## PJM Manual 14D:

Generator Operational Requirements

~~Revision: 59~~ Revision: 60

Effective Date: ~~September~~ October 1, 2022

Exhibit XXX. An example of real-time data and account metering requirements for a Mixed Technology Facility, including measurement points. This facility is 75 MW or larger and

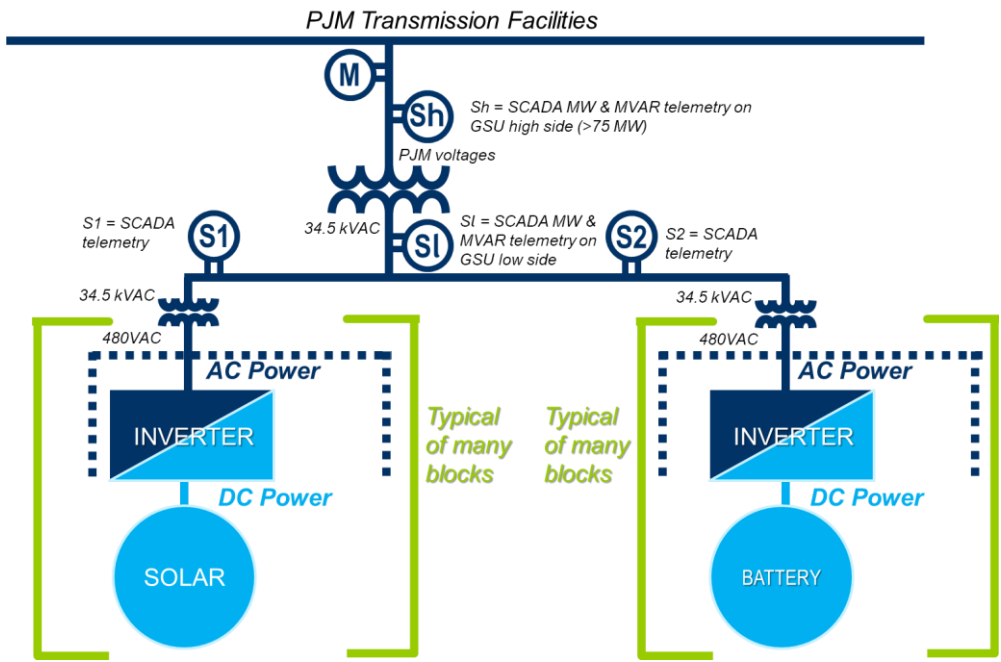
Exhibit XXXXX below illustrates an example of a Mixed Technology Facility with a solar resource and an Energy Storage Resource, each participating separately in markets as a Co-Located Resource. In this example, all of the energy measured for the Mixed Technology Facility at "M" across an interval (e.g., 5 minutes) is split between the solar resource and the Energy Storage Resource pro rata according to the power measured at S1 (which measures all of the solar production) and at S2 (which measures all of the storage power flows) integrated over the interval.

Exhibit 11: Generation Deactivation Process Flow

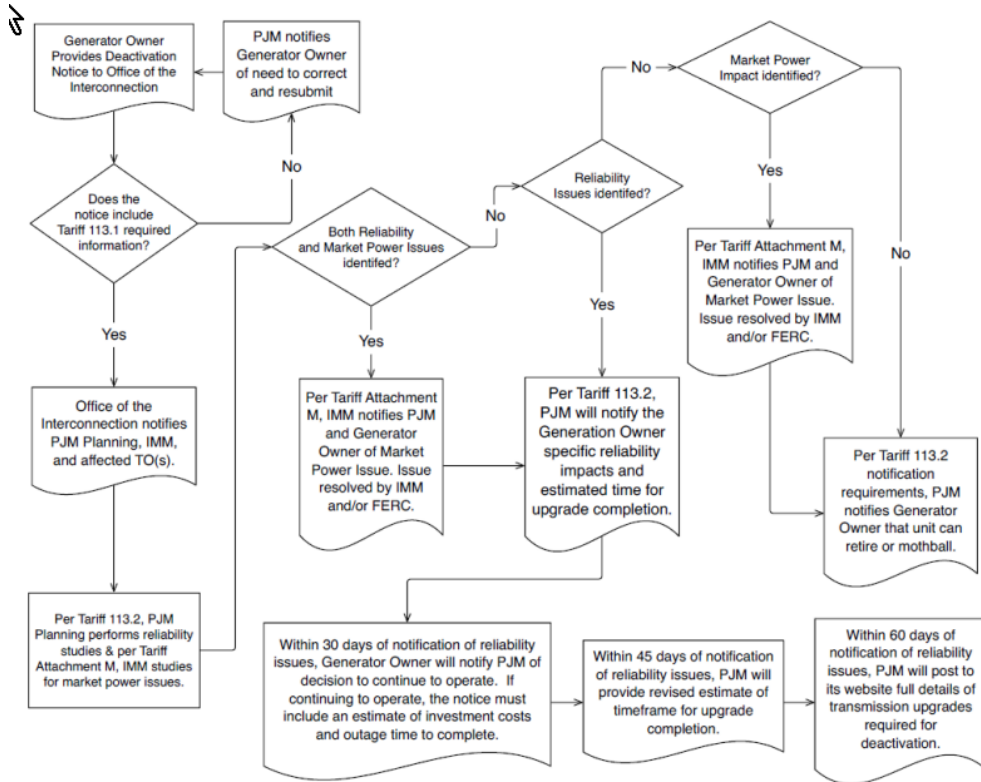
~~The following exhibit displays the generation deactivation process flow:~~
